### (S.16 Planning Application No. A/YL-HTF/1151)

We are writing to submit supplementary information to provide clarifications for the subject application, details are as follows:

Departmental Comments	Applicant's Responses
1.	Comments of the Chief Town Planner/Urban	Design and Landscape Section, Planning
1	Department (CTP/UD&L, PlanD)	
(	(Contact Person: Mr. Brian LAM; Tel: 3565 39	49)

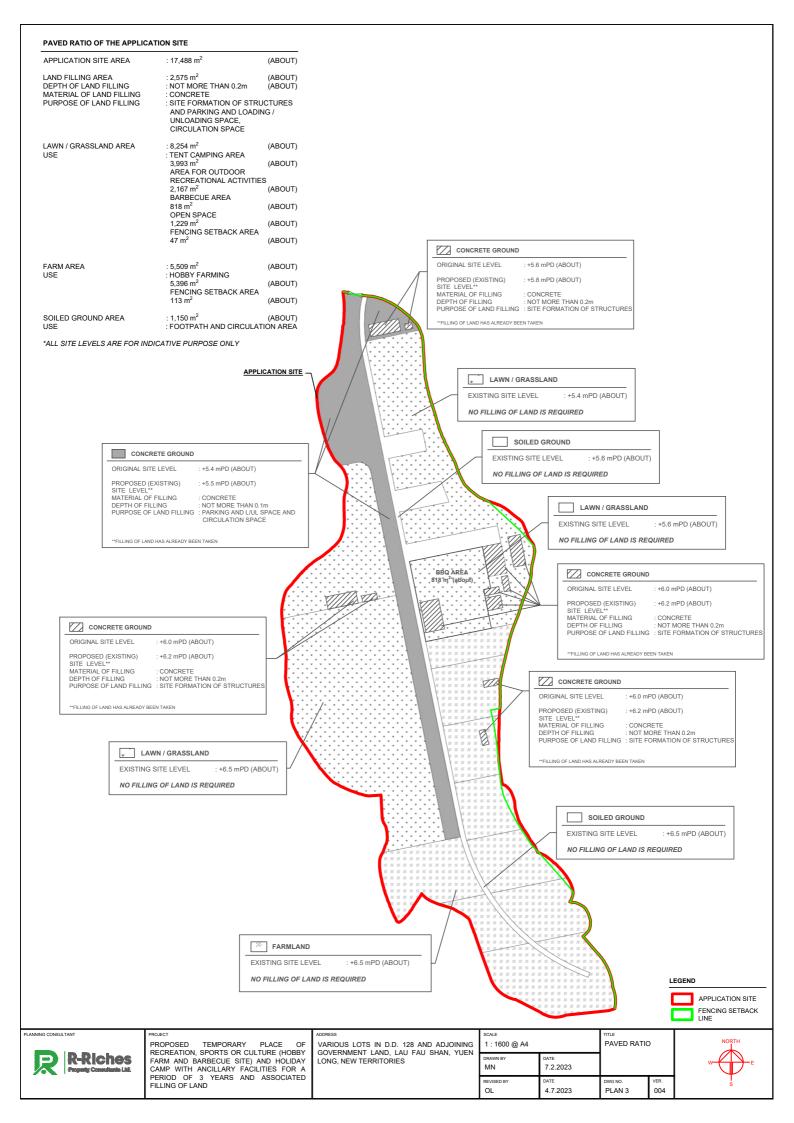
(a)	In Item 6(e) – "Impacts of Development	According to the tree survey report
	Proposal" of the application form, it is	conducted on $4/4/2023$ , a total of <u>34</u>
	noted that "NO Tree Felling" would be	nos. of trees are recorded within the site
	caused by the development. As shown	boundary (Annex II). No OVT or
	from the aerial photo dated 2022,	protected species has been identified in
	scattered tree groups at the southern	accordance with the DEVB TC(W) No.
	corner within the application site are	5/2020 – Registration and Preservation
	observed within the proposed "Farm Area"	of Old and Valuable Trees and the
	of the proposed Layout Plan. Information	Forests and Countryside Ordinance
	of landscape technical assessment on the	(Cap.96) respectively. 8 out of total 34
	landscape resources (i.e. existing trees)	nos. identified existing trees are
	within the site and landscape proposal to	proposed to be felled while the

mitigate the impact due to the proposed	remaining 26 nos. are proposed to be
	development were not included in the	preserved ( <b>Plan 2</b> ).
	submission. The Applicant should provide	
	the landscape proposal for mitigating the	Due to the felling of existing trees within
	landscape impact arising from the	the Site, 8 new trees with are proposed
	development for review.	to be planted to compensate the loss of
		the 8 existing trees. They will be planted

at the tent camping area within the Site ( <b>Plan 2</b> ). All these new trees within the Site will all be maintained by the applicant.
(b)	As the proposed development is next to existing woodland within the same "GB" zone, existing ponds are located within the adjacent "CPA" zone and in close proximity to the site, there is no similar application for temporary place of recreation, sports or culture (hobby farm and barbecue site) and holiday camp use previously approved in the same "GB" zone, the proposed development is considered incompatible with the surrounding landscape resources (woodland) and landscape character (rural landscape) from the landscape planning perspective.	The applicant intends to operate the applied use to promote local camping and hobby farming at the Site. Under the proposed scheme, only a minor portion of the Site (i.e. about 2,575 m <sup>2</sup> , 15%) has been hard-paved, while the remaining area are designated for tent camping, hobby farming and circulation area ( <b>Plan 1</b> ). The camping and recreational farming activities are similar to the always permitted 'tent camping ground' use and 'agricultural use' within the subject "Green Belt" ("GB") zone, therefore, approval of the application on a temporary basis will not frustrate the long term planning intention of "GB" zone.

<sub>icale</sub> 1 : 1500 @ A4		CATCHMENT	
RAWN BY MN	Litter Litte		
EVISED BY	date 13.7.2023	DWG NO. DIA 2	ver. 001

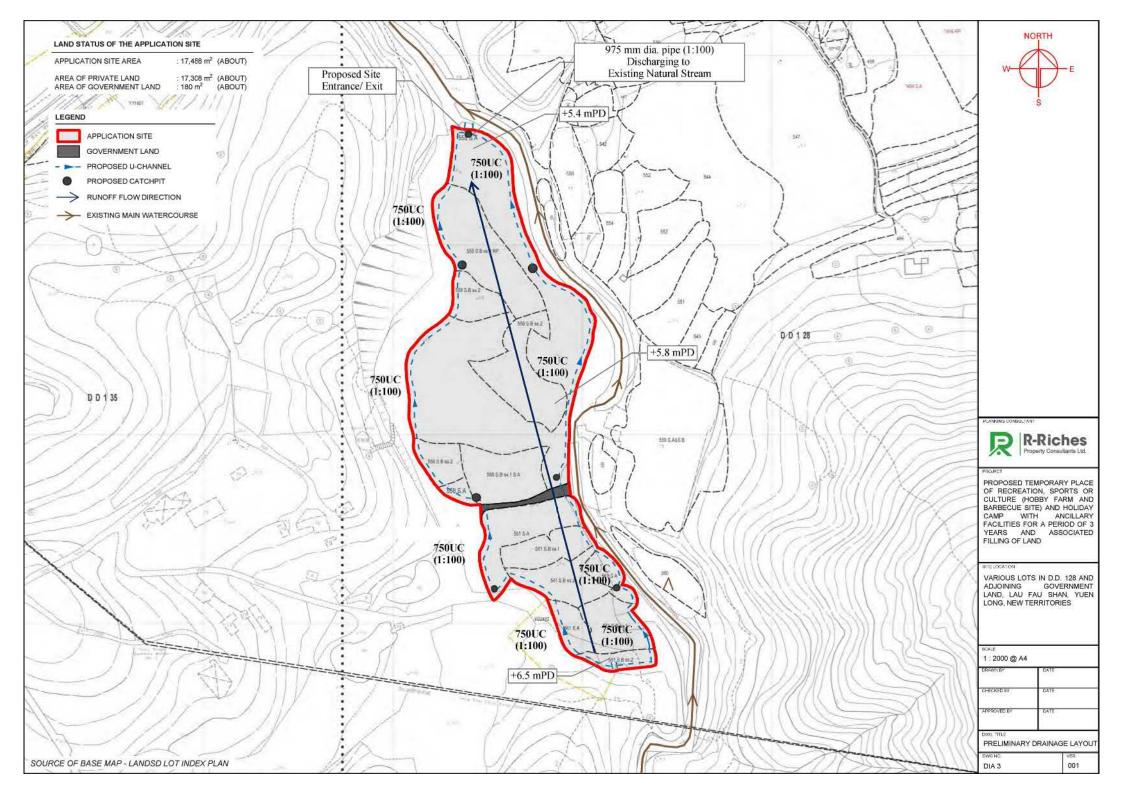
(b)	Since the overland flow from the adjacent lands (e.g. western side of the site) shall be probably intercepted, the external catchment shall be considered in the calculation of your proposed channels.	The overland flow from the western side of the site is considered as an external catchment. The proposed drainage system is designed to cater the overland flow. For the extent of the external catchment, please refer to Drawing No. DIA2 in Appendix A.
